# UNITED STATES PATENT AND TRADEMARK OFFICE

APPLICATION NO.	FILING DATE	FIRST NAMED INVENTOR	ATTORNEY DOCKET NO.	CONFIRMATION NO.
09/688,989	10/17/2000	Yoshitaka TSUNASHIMA	04329.1952-01000	2408

# Office Action Summary

***Response to Amendment***

FIG. 3(d)

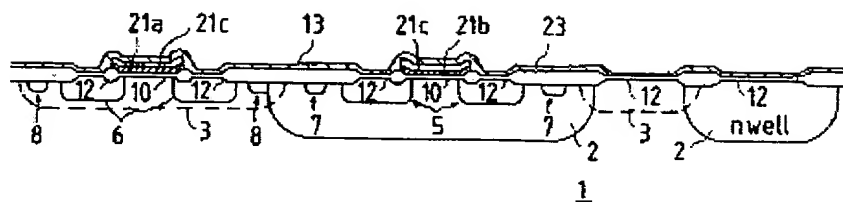
Applicants contend that Tada does not disclose/ suggest that the sidewalls of the gate electrodes are connected.

However Tada in Figure 3D shows element (21) connecting gate electrodes sidewalls 13 a and b. ( reproduced below).

Therefore contrary to applicants' contention all of the presently recited limitations of the claims, including sidewalls of the gate electrodes 13 a and 13 b are connected by element ( polysilicon layers) 21 a and 21 b ( col. 8 lines 1-11) is taught , (and to the extent understood " a sidewall of the first gate electrode at one end of a channel direction is connected to a side wall of said gate electrode at one end of the channel direction" ) by Kume and Tada and therefore prima facie obviousness has been established.
